State of New Mexico
Energy, Minerals and Natural Resources

7. Lease Name or Unit Agreement Name
West Dollarhide Drinkard Unit

8. Well Number 151

SUNDRY NOTICES AND REPORTS ON WELLS

WDDU #151

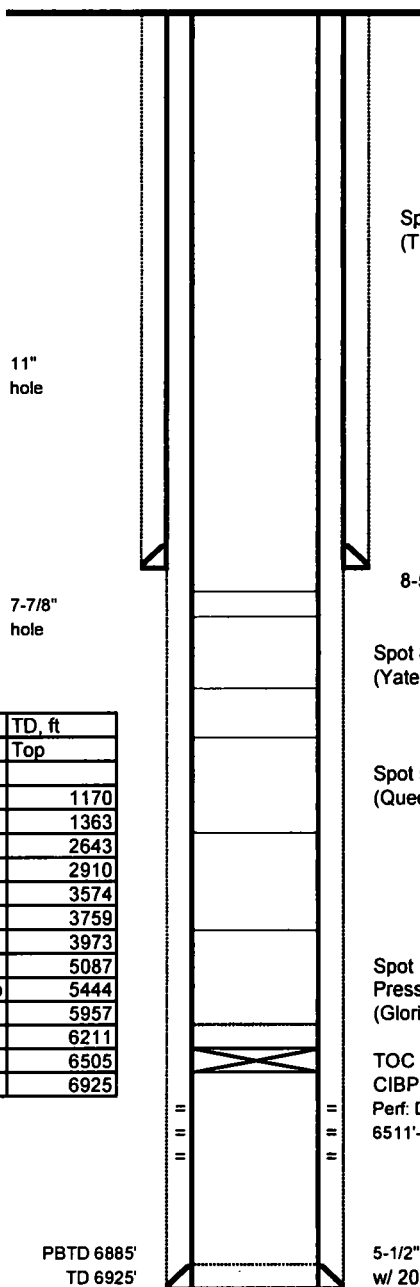
Chevron USA Inc respectfully requests to abandon this well as follows:

1. MIRU coil unit
2. Spot 130 sx CL C cement f/ 6275' to 4961' (Perfs, Tubb, Glorieta). Pressure test to 1000 psi for 15 minutes
3. Spot 55 sx CL C cement f/ 4023' to 3467' (San Andres, Grayburg, Queen)
4. Spot 85 sx CL C cement f/ 2960' t/ 2101 (7 Rivers, Yates)
5. Spot 140 sx CL C cement f/ 1413' t/ surface' (TSalt, Shoe, Anhy, FW)
6. Verify TOC @ surface, RDMO, and turn over to site reclamation

**See Attached
Conditions of Approval**
